Request for Bid
Loos Interceptor Diversion Construction Addendum No. 2 to
RFB No. 199498.71.0394
May 8, 2019

LOOSAHATCHIE DIVERSION
SEWER

INVERTED FRP TEE
MANHOLE DETAIL

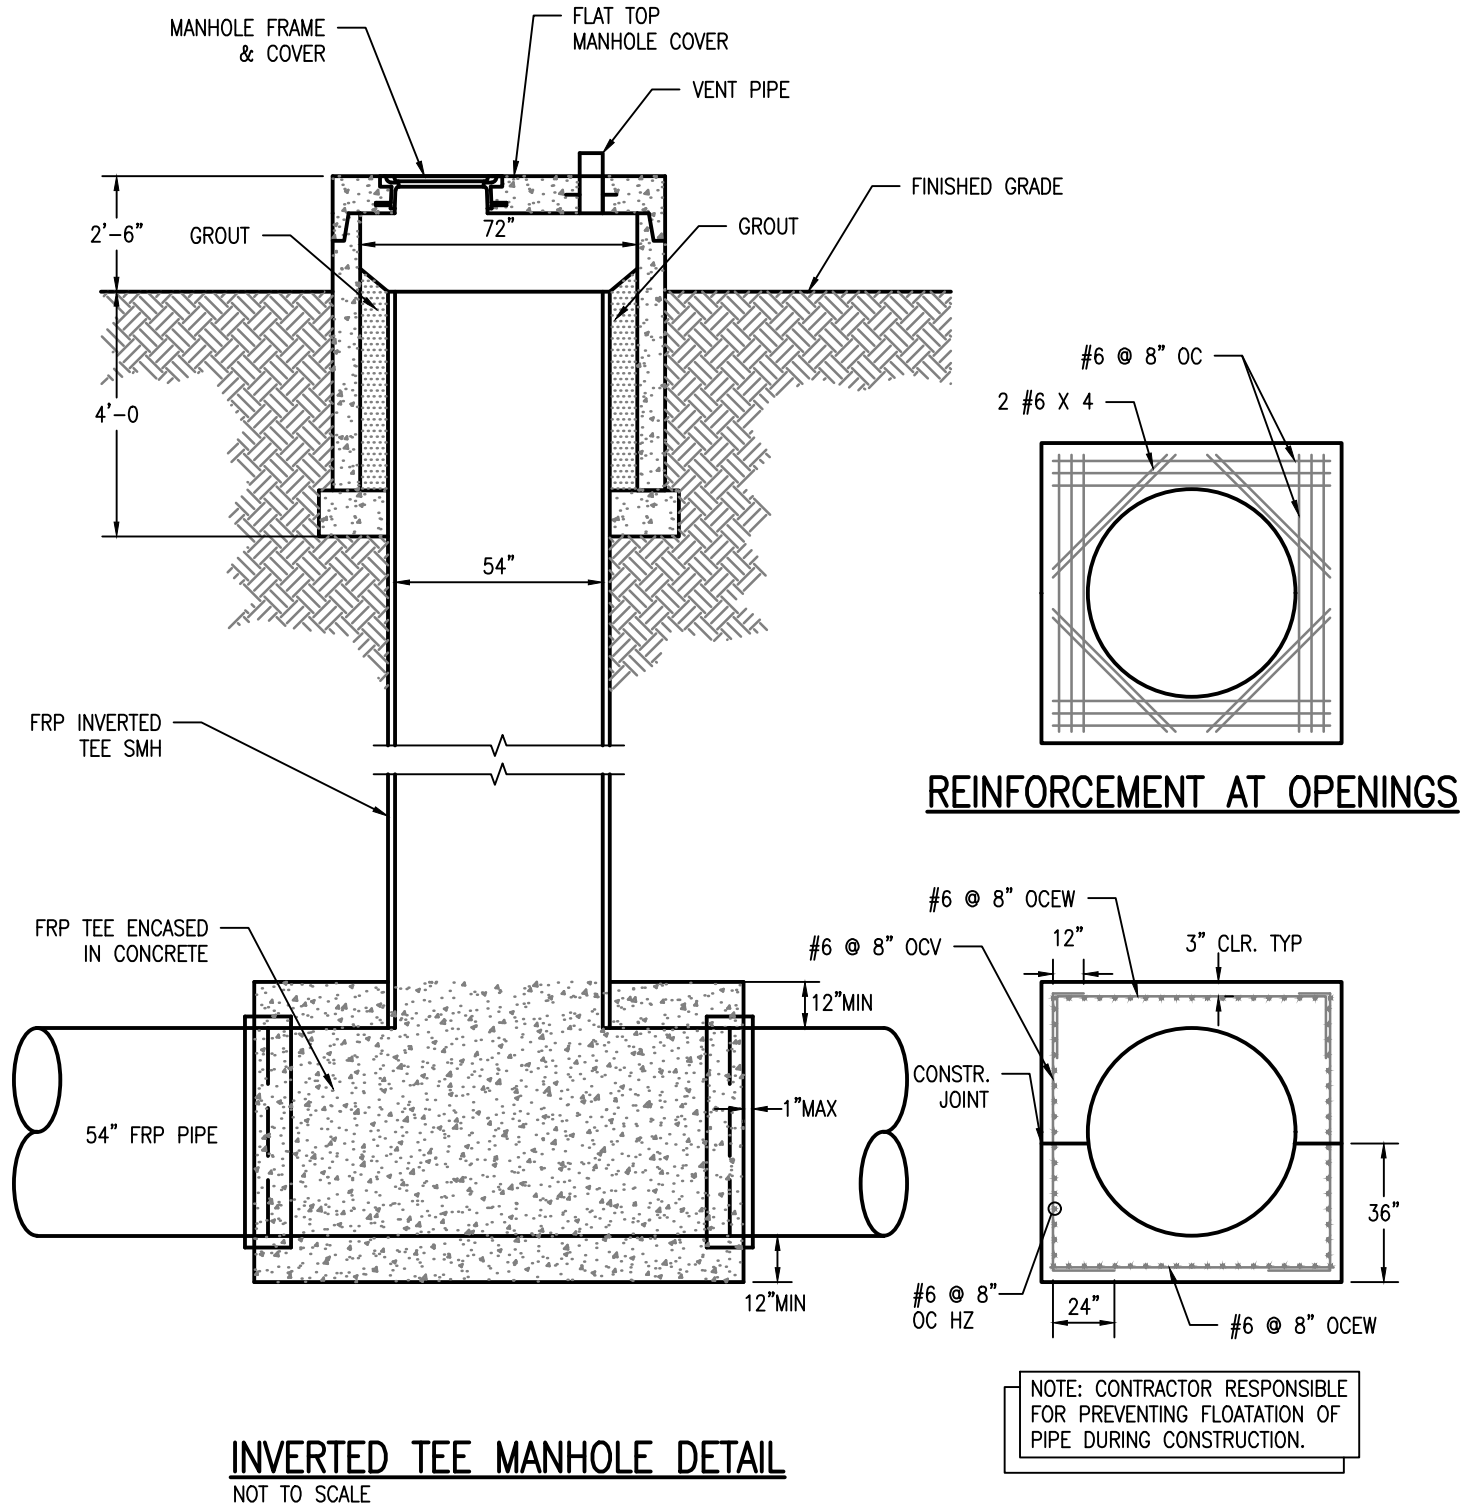
Q5: Bid Item: 02531-6.01.54, 54" FRP Inverted Tee Manhole Installation. There is no detail on this bid item. In the past I have seen the Tee Manhole base section be encased in concrete and the upper section encased with a concrete SMH over the outside of the FRP pipe section with a concrete flat top. Can a detail be provided for this bid item from subgrade to top elevation?

SARP10: Yes, a detail will be provided as part of this addendum.
